Product Change Notice (PCN)

PCN Number: **PCN-0456246R-01**

Product(s) Affected: **SJ1-2503A**

PREVIOUS CUI DEVICES DETAIL / IMAGE	NEW CUI DEVICES DETAIL / IMAGE

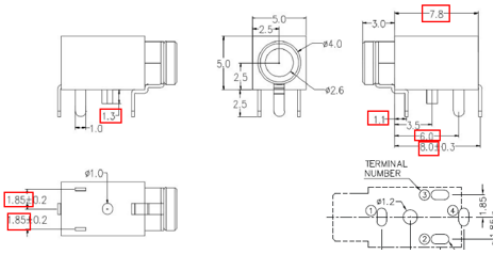
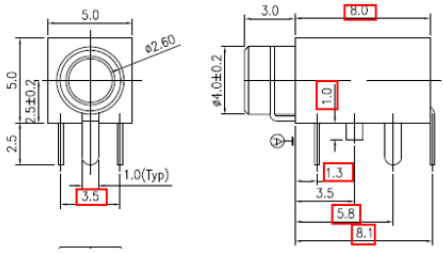
Description of Change: **New Factory Location. Product re-engineered for improved manufacturability and production yield. See image below for reference and check CUI Devices website for updated drawing. Cosmetic differences may be visible and not affect the form fit and function of the product.**

PREVIOUS CUI DEVICES DETAIL / IMAGE			NEW CUI DEVICES DETAIL / IMAGE		
DESCRIPTION	MATERIAL	PLATING/COLOR	DESCRIPTION	MATERIAL	PLATING/COLOR
terminal 1	brass	silver	terminal 1	phosphor bronze t=0.30	tin over nickel
terminal 2	copper alloy	silver	terminal 2	phosphor bronze t=0.30	tin over nickel
terminal 3	copper alloy	silver	terminal 3	phosphor bronze t=0.30	tin over nickel
terminal 4	copper alloy	silver	terminal 4	brass t=0.30	tin over nickel
bushing	brass	nickel	bushing	copper alloy	nickel
housing	PBT (UL94V-0)	black	housing	PAB (UL94V-0)	black
